SECTION 4.55(1A) Modification

65-69 Lorikeet Grove, Warriewood

Prepared for **COLONIAL CREDITS** 16 July 2020

Figure 4 Proposed Northern elevation Plan

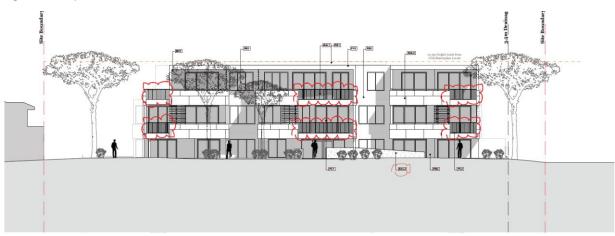
The approved glazed balustrades are proposed to be replaced with vertical flat bar balustrades on all balconies. The proposed changes are the result of post-approval design changes and are considered to be complimentary to the fixed metal privacy screening and earth tones of the façade, further improving the appearance of the development. The proposed balustrades will not impact on solar access to apartments and ensure the same level of privacy to balconies as the approved design.

Figure 3 and 4 below illustrate the approved and proposed northern elevation.

Figure 6 Proposed Rooftop Communal Open Space

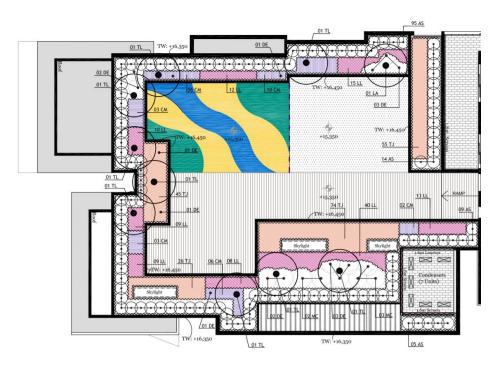
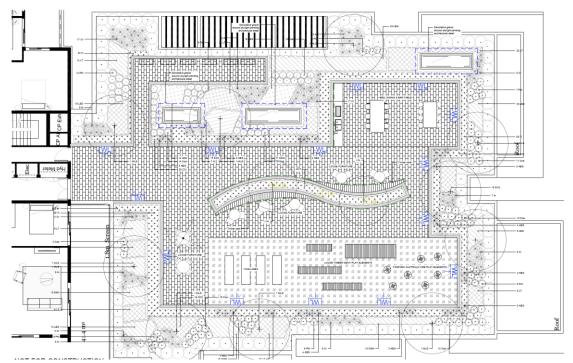
- Ground Floor and Level 1:
 - Additional native and locally found species throughout;
 - Changes to some proposed plant species;
 - Additional plant species to lobby entries and communal areas; and
 - Increase in number of trees within both levels.
- Level 3:
 - Minor amendments to seating, dining and play elements due to use of alternative products and improvements to the layout;
 - Changes to plant species including introduction of exotic and hardy plant species that are considered more suitable for a rooftop environment;
 - Amendments to the communal roof area through improvements to the quality of the landscape spaces, including lush aesthetics which soften the built form and create points of interest.

Figure 5 and 6 below illustrate the approved and proposed landscape design of the rooftop communal open space.

Figure 7 Approved Roof design

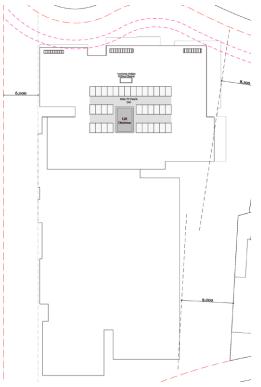
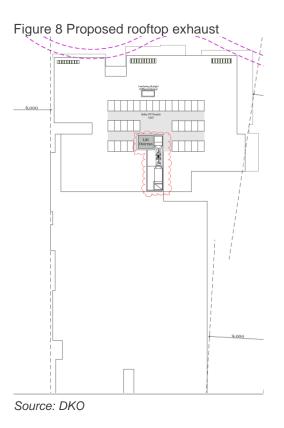
A rooftop exhaust system is proposed adjacent to the lift overrun. The exhaust system assists with the operation of the approved development and does not exceed the maximum building height limit for the site.

Figure 7 and 8 below illustrate the approved roof design and proposed location of the exhaust system.

The proposed exhaust system on the rooftop provides improvements to the operations of the development. The exhaust is proposed to be behind the lift overrun, and does not exceed the maximum building height for the site as specified under PLEP 2014. The proposed location within the centre of the roof structure and south of the liftoverrun ensures visual impacts are minimised from the streetscape and surrounding sites.

Figure 10 Proposed location of Hydrant Booster Assembly

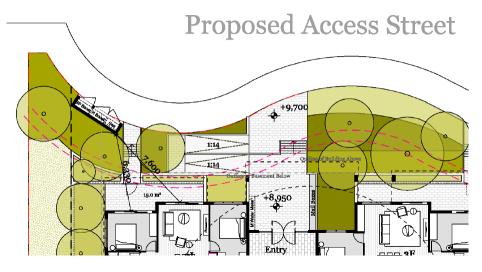
The relocation of the hydrant booster assembly is proposed due to Sydney Water allocating Lorikeet Grove as the water supply for the development. The relocation is proposed to ensure efficient access and clarity for NSW Fire Brigade in the event of a fire emergency.

Figure 9 and 10 below illustrate the approved and proposed location of the hydrant booster assembly.

Figure 12 Extension of AC Condenser Room

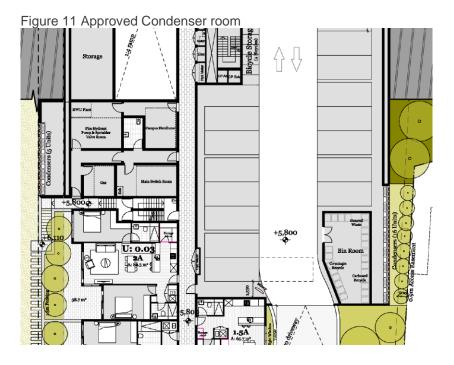
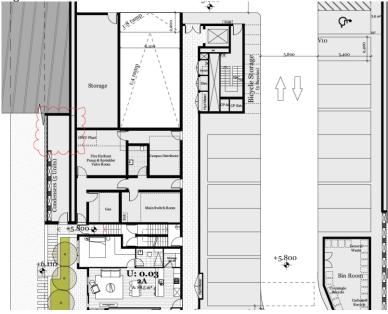
A minor extension of the air conditioner (AC) condenser room within the basement is proposed to allow for improved efficiency within the room. The proposal seeks to increase the length of the room by 1.5m and would generally remain below ground level. The minor extension of the room would remain within the previously excavated site, therefore not require additional excavation.

Figure 11 and 12 below illustrate the approved condenser room and proposed extension.
